Campaign no. 97001
(670 Engine)

No. **97-1**

SUBJECT: Needle Bearing Replacement

SUBJECT: Carburetor Flange Clamps

- 1. Needle bearing
- 2. Circlip

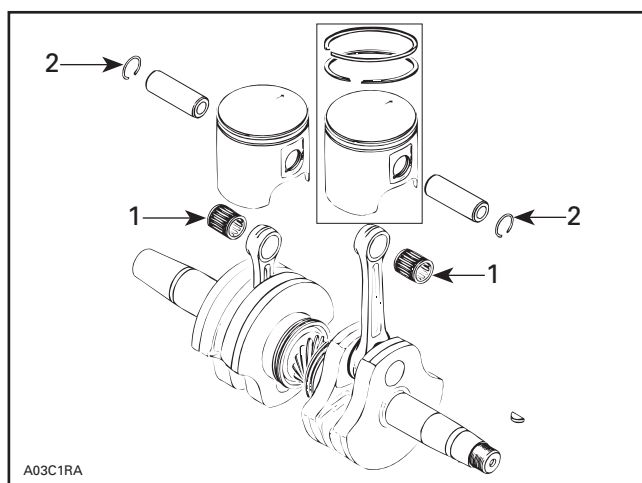
Improper heat-treatment applied to piston needle bearings.

Replace existing needle bearings with new ones.

1. Existing clamp
2. New clamp

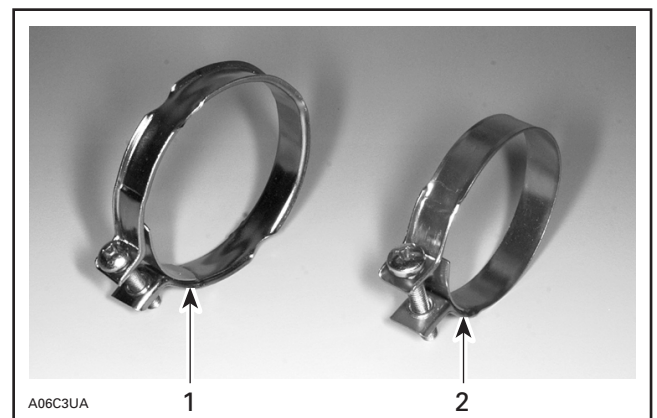
The clamps retaining carburetors to the rubber flanges may slide out of place when tightening. This situation may lead to air leak and engine failure.

Replace existing clamps with new ones.

Torque to 0.5 N•m to 0.8 N•m (4.5 lbf•in to 7.3 lbf•in).

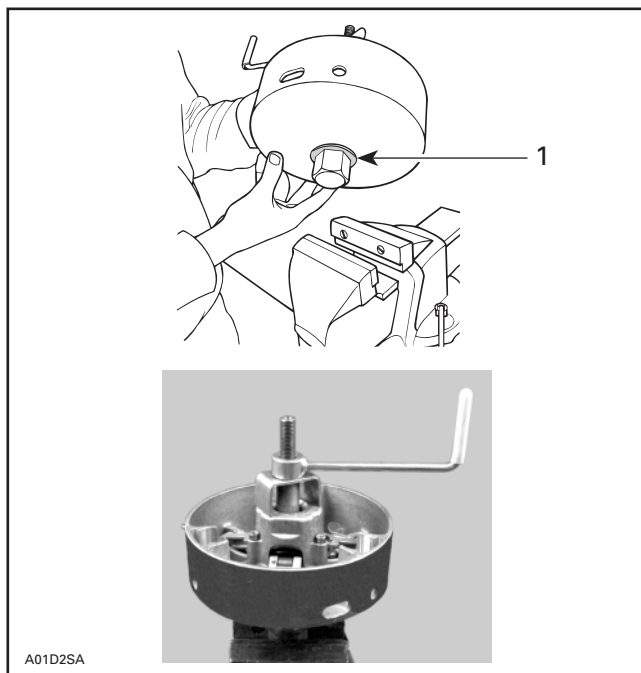
The 3 Allen screws retaining the spring cover on the sliding half of the drive pulley may be insufficiently torqued.

Re-torque the 3 Allen screws to 13 N•m (9.5 lbf•ft).

If threads on the sliding half have become damaged, replace the sliding half with new part.

1. Modify this tab (one on each side)

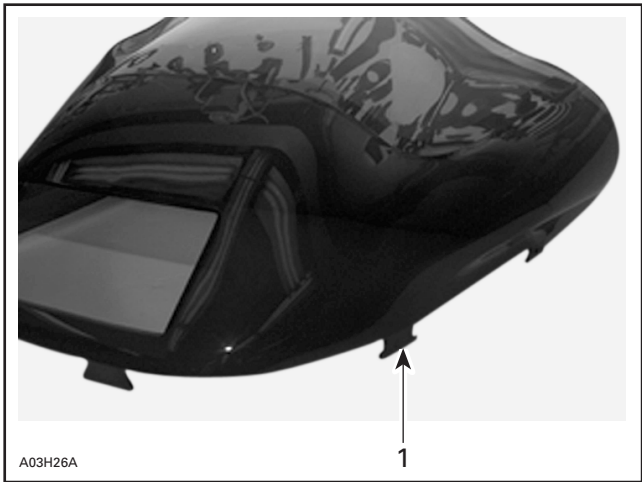
Windshield may become loose due to rubber straps sliding off of the 2 tabs that are located on the sides nearest to the front on windshield base.

Modify the 2 tabs located on the sides, nearest to the front as shown on the following photo.

- 1. Before
- 2. Existing shape
- 3. After
- 4. Modify to look like this
- A. 19 mm (3/4 in)

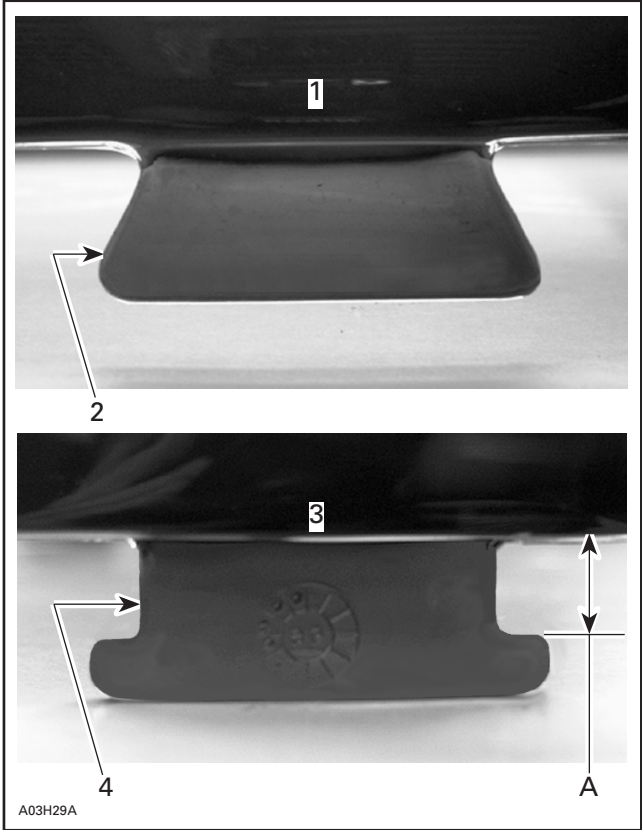
- Ensure engine is turned off.
- Open hood.
- Remove 6 rubber straps from windshield base.
- Remove windshield.
- Modify tabs using a file or cutters as indicated in the following photo.

1. Actual cam pulley angles (44/40)
2. New cam pulley angles (40/44)

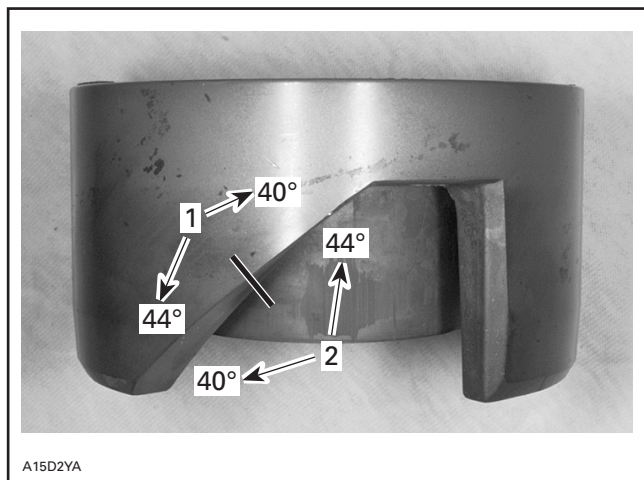
On the above mentioned snowmobiles, the driven pulley cam has incorrect cam angles. This results in poor performance at low revolution and over revving at mid range.

Replace driven pulley cam with new one. In order to obtain optimum engine performance, the new cam angles match the stock pulley calibration from factory.

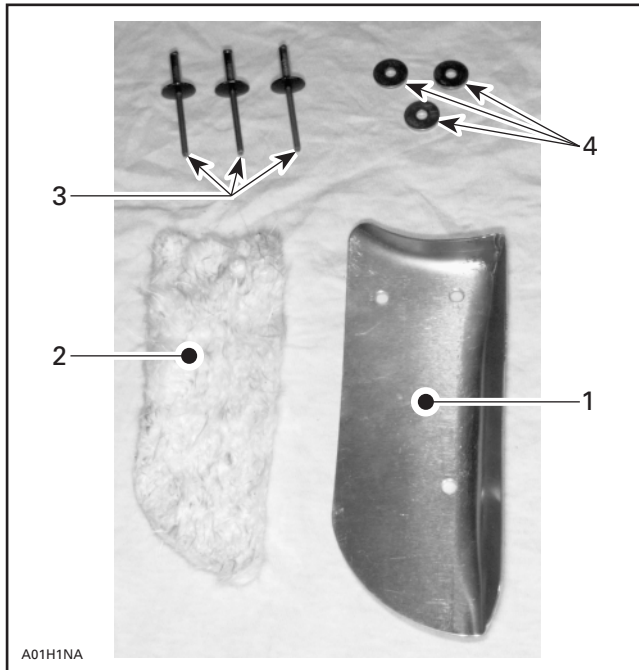
Bottom pan material may be damaged by high temperature exhaust gas at exhaust outlet location, beside right hand swing arm attachment.

Install an insulator pad and a protective plate, then secure with rivets.

- 1. Needle bearing
- 2. Circlip

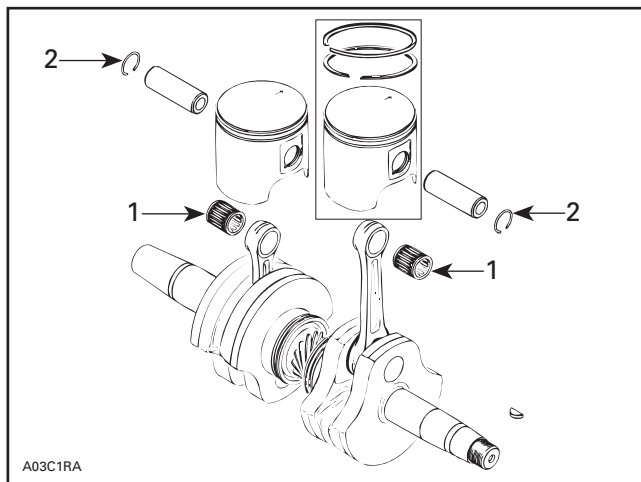
Improper heat-treatment applied to piston needle bearings.

Replace existing needle bearings with new ones.

➡ **NOTE:** Each cageless bearing contains 28 needles.
